ALLAMAKEE CSD MIDDLE SCHOOL HVAC UPGRADE
WAUKON, IOWA

ADDENDUM 01
March 2, 2026

DRAWN BY	DMS
CHECKED BY	KDM
PROJECT NO.	9166-10000
SHEET NAME	ELECTRICAL PLAN - OVERALL

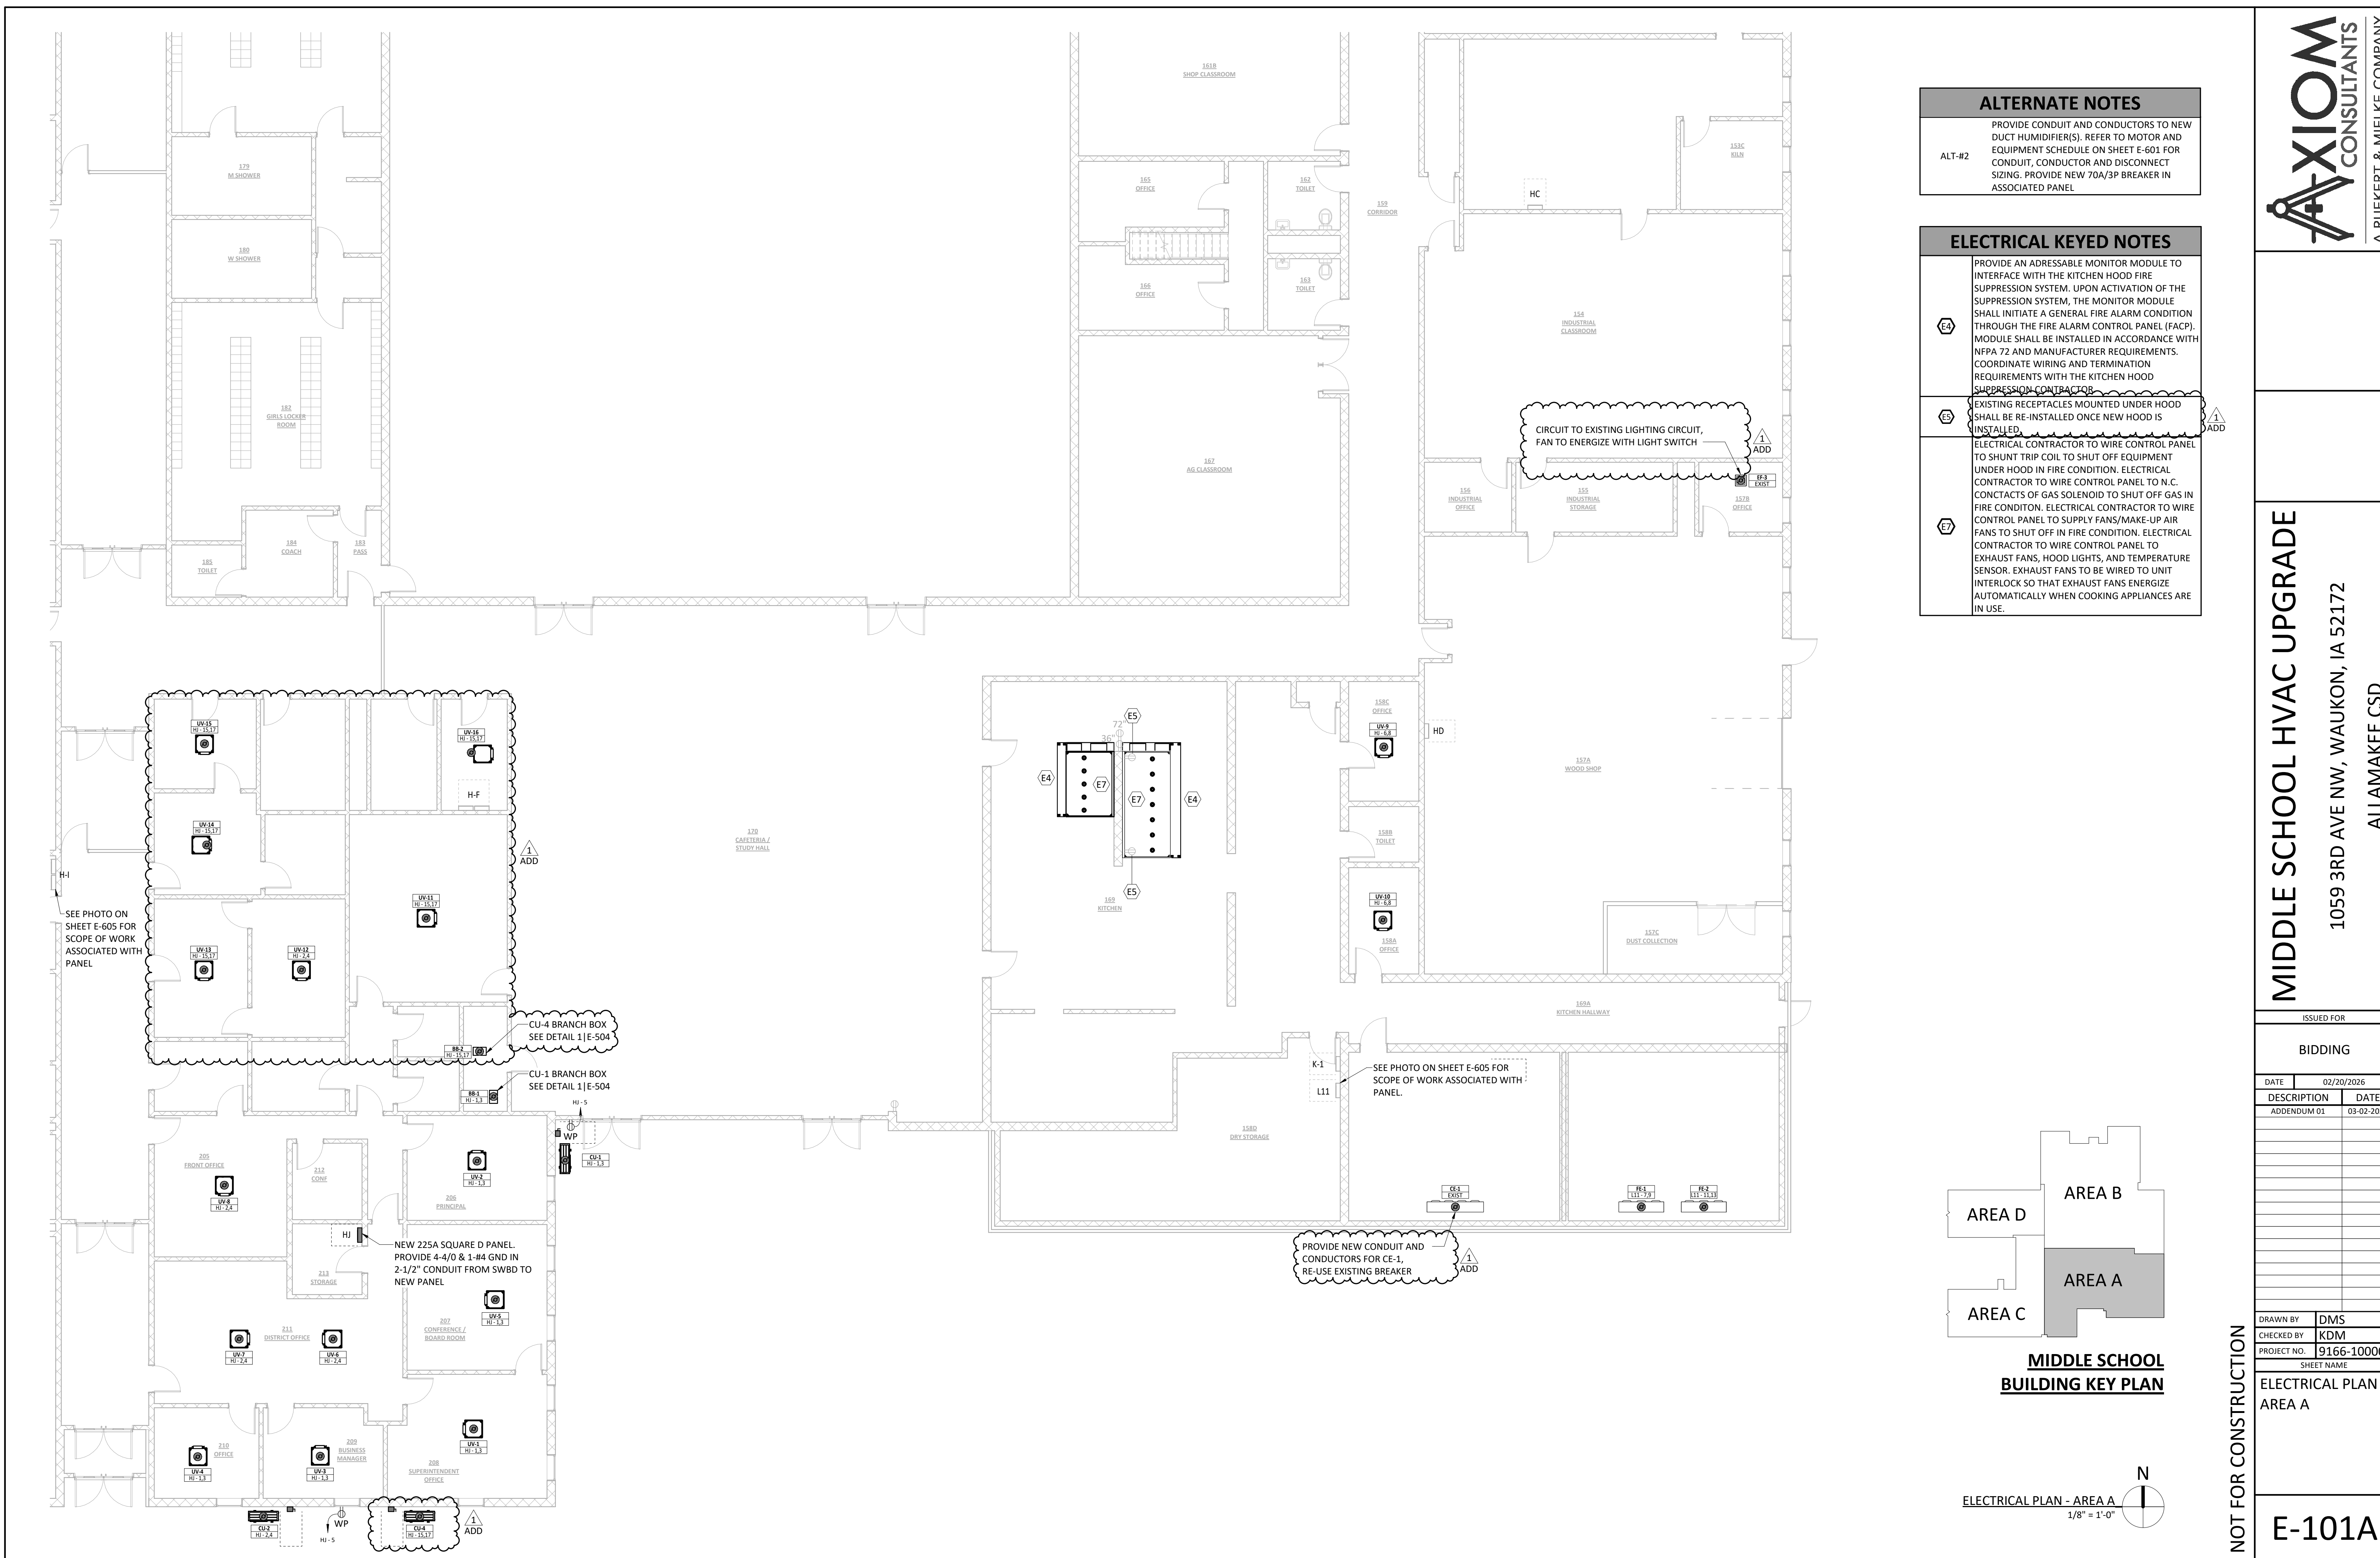
1. Added circuit for one (1) new outdoor condensing unit.
2. Revise DH-3 (Alternate #2) circuit to panel HJ.
3. Revise EF-1 circuit to panel HJ.
4. Revised MAU-1 circuit and added (2) additional circuits to feed three (3) smaller MAU's: MAU-1, MAU-2 and MAU-3.
5. Revised DOAS-5 circuit to panel K-1.
6. Revised KEF-circuit to existing spare circuit K-1-22.

ELECTRICAL PLAN - AREA A

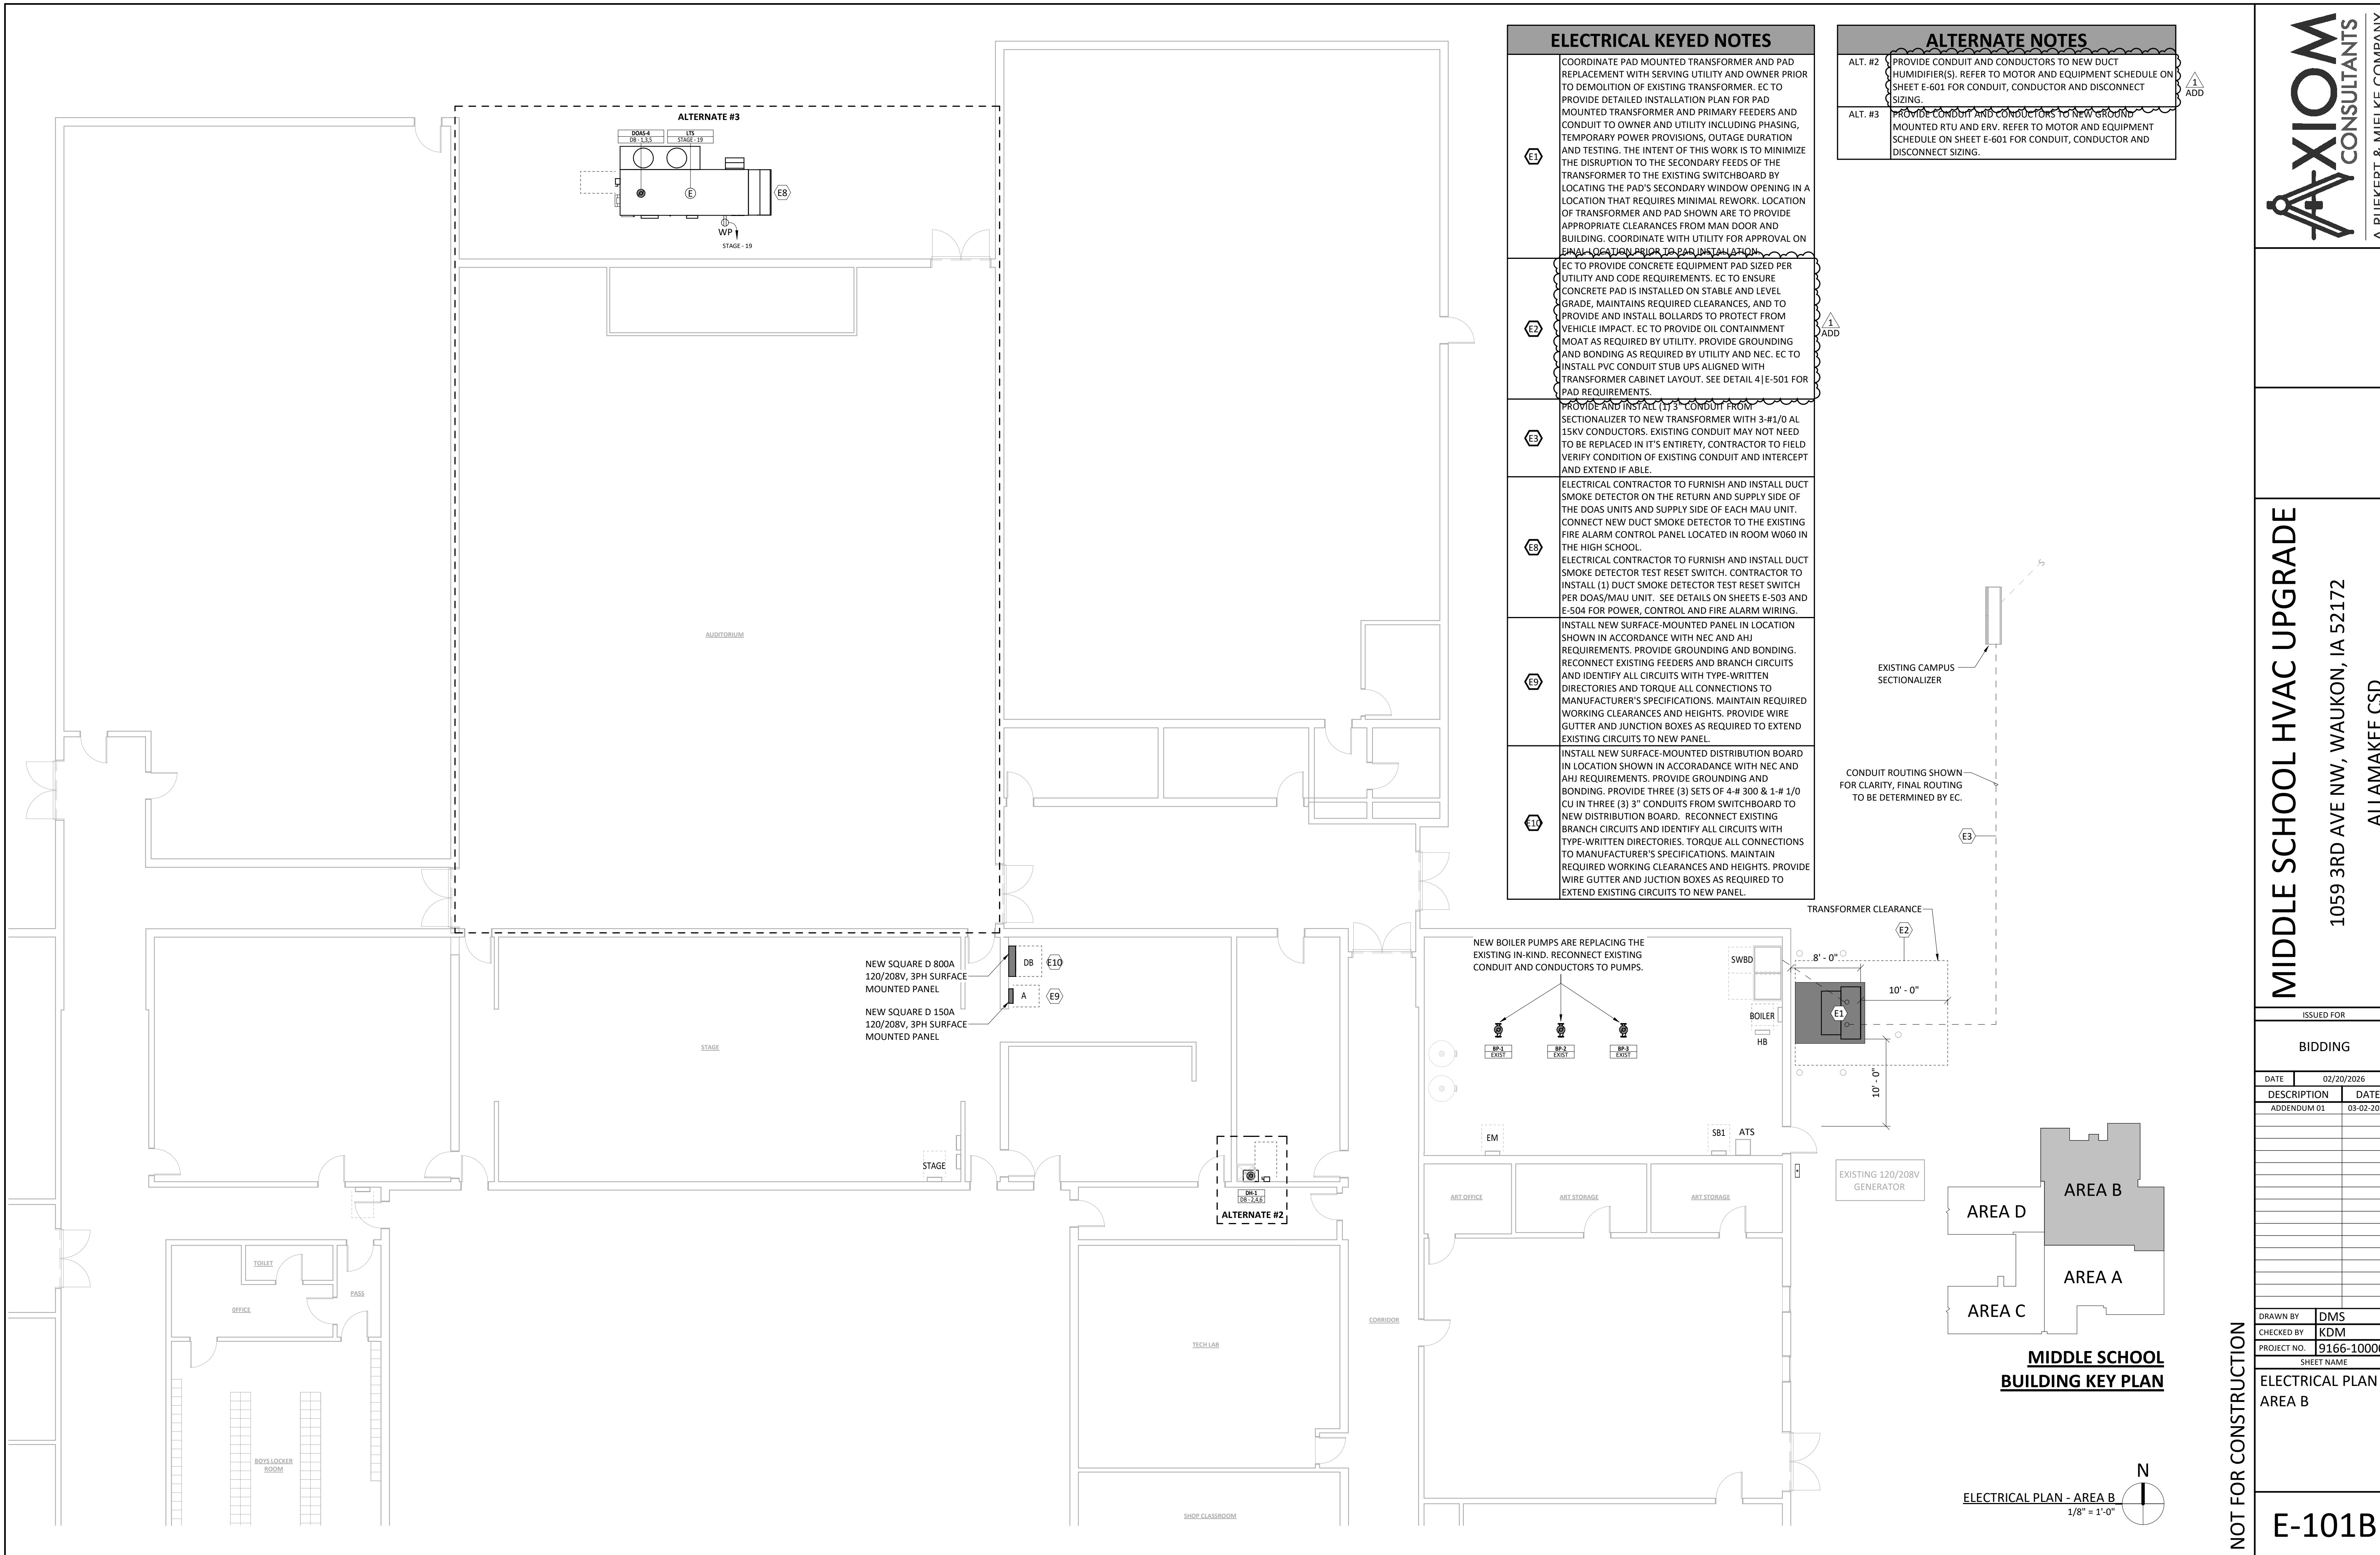
1. Added circuit for one (1) new outdoor condensing unit, six (6) new unit ventilators, and one (1) new branch box for the north admin area.
2. Added note to provide new conduit and conductors for CE-1 while re-using the existing breaker.
3. Added note to circuit new exhaust fan to the existing lighting circuit.
4. Revised electrical keynote E5.

ISSUED FOR	
BIDDING	
DATE	02/20/2026
DESCRIPTION	DATE
ADDENDUM 01	03-02-2026
DRAWN BY: DMS	
CHECKED BY: KDM	
PROJECT NO.: 9166-10000	
SHEET NAME	
ELECTRICAL PLAN - AREA B	
E-101B

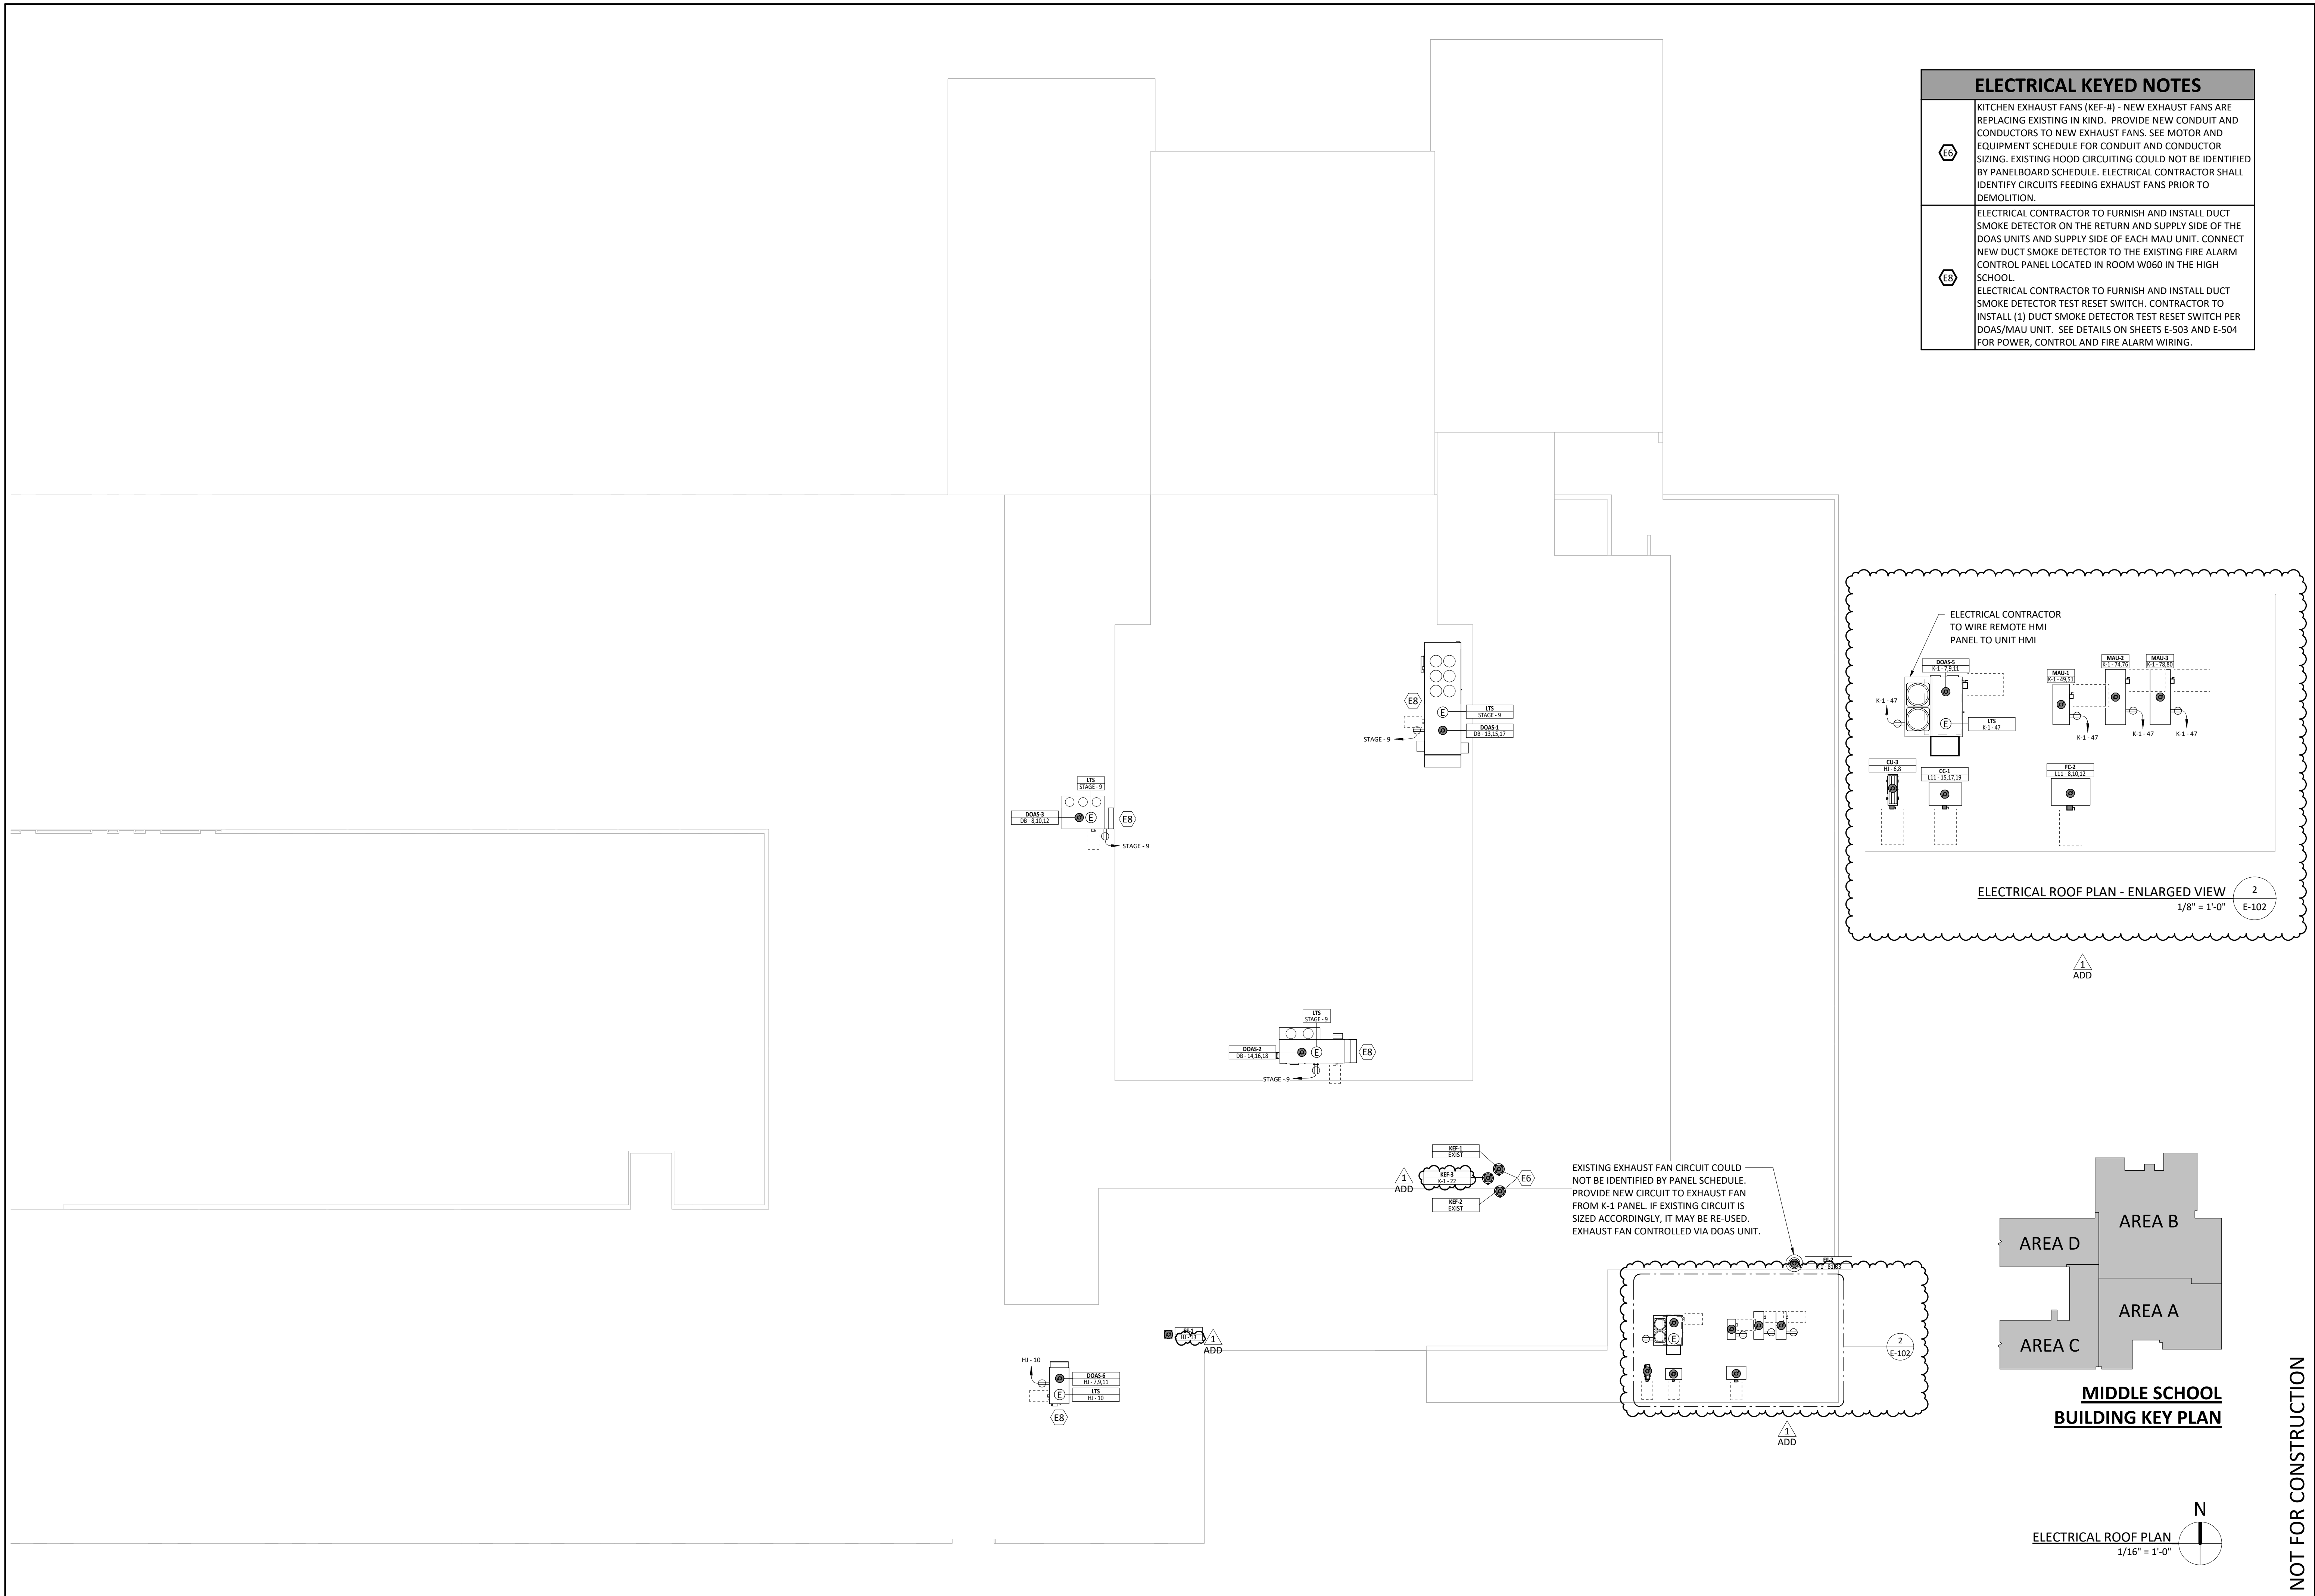
1. Revised electrical keynote E2.
2. Revised Alternate #2 note.
